Tie rod end
Tie rod

Tie rod end to fit Audi A8, VW Phaeton

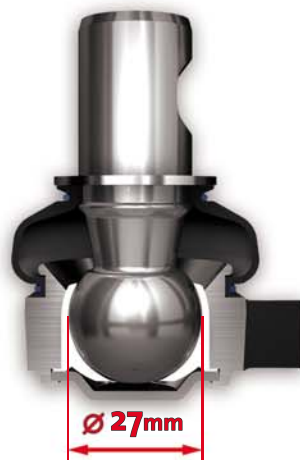
Problem

Intense strain and high surface pressure wears on the tie rod end (head \varnothing 27 mm)

Effect

Noise and play in the steering

Solution

Increased diameter of the ball head of the tie rod end to 29 mm

Reduction of the surface pressure ensures a significant longer lifetime
